SSDA Access Report

UoN Central Coast Campus
305 Mann Street
GOSFORD NSW

For: Lyons
Ref: LP_22203

State Significant Development Application (SSDA) documentation for the University of Newcastle Central Coast Campus located at 305 Mann Street Gosford, has been reviewed against current accessibility legislation.

Figure 3 | Access through the Site (section)

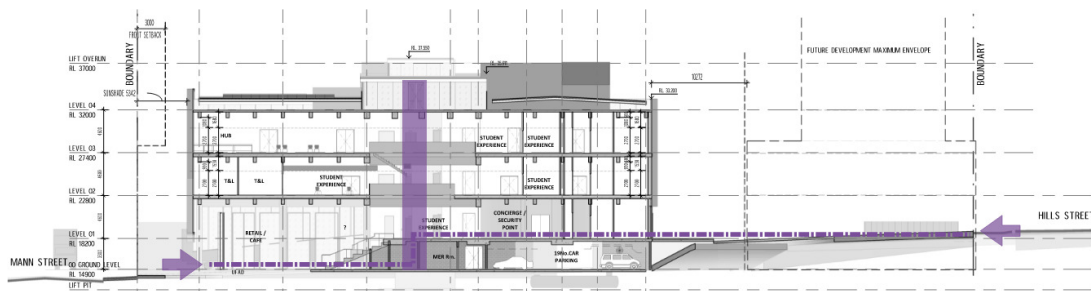
The accessible approach to the development is provided from the southwestern corner of the site (corner of Mann and Beane Street).

A walkway is provided from this point for access to the forecourt area and building entrances. Due to the topography of the site, that is challenging with respect to accessibility, this will be the only accessible entrance along the streetscape. It provides the most practical entrance with respect to the surrounding streetscape and infrastructure.

The journey through the building will facilitate access to Hills Street, via the lifts that are located centrally within the development. Accessible car parking is provided at the ground floor level
